S E R V I C E N O T E

**E2225A/E8600A Calibration System Modules
E9119A Calibration System CON2 Module**

CON2 SRAM Data Loss modification.

Figure 1. CON2 SVRAM Data Loss Modification

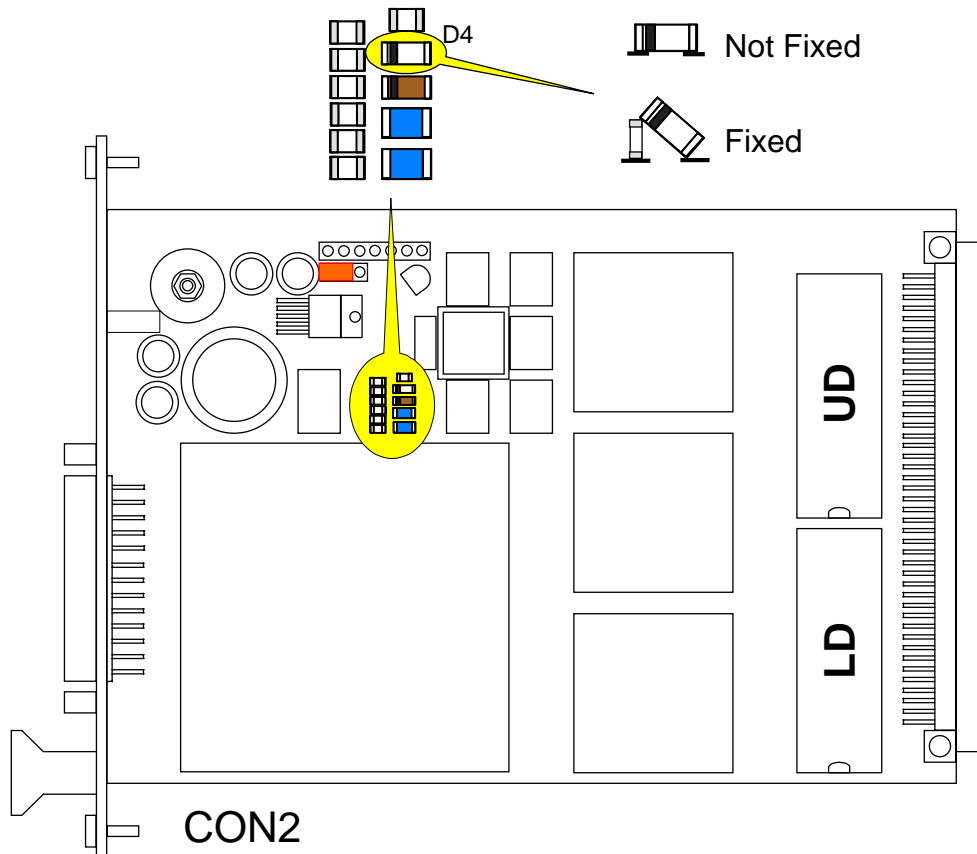
The CON2 module can experience data loss under extreme environmental conditions causing the power supply voltage rise time to be unusually long. Such conditions do occur however, during routine (and specified) use of the CAS.

The problem occurs because of a design error made by our supplier. The supplier has agreed to fix faulty modules free of charge. Because of the nature of the HW-modification required to fix the problem the repair cannot be done in the field. Therefore the recommended repair strategy is PCA-exchange.

The fix can be recognized by looking at the SMT diode marked D4 in figure 1. If the diode is replaced by a combination of an SMT resistor and a diode, the board has been fixed.
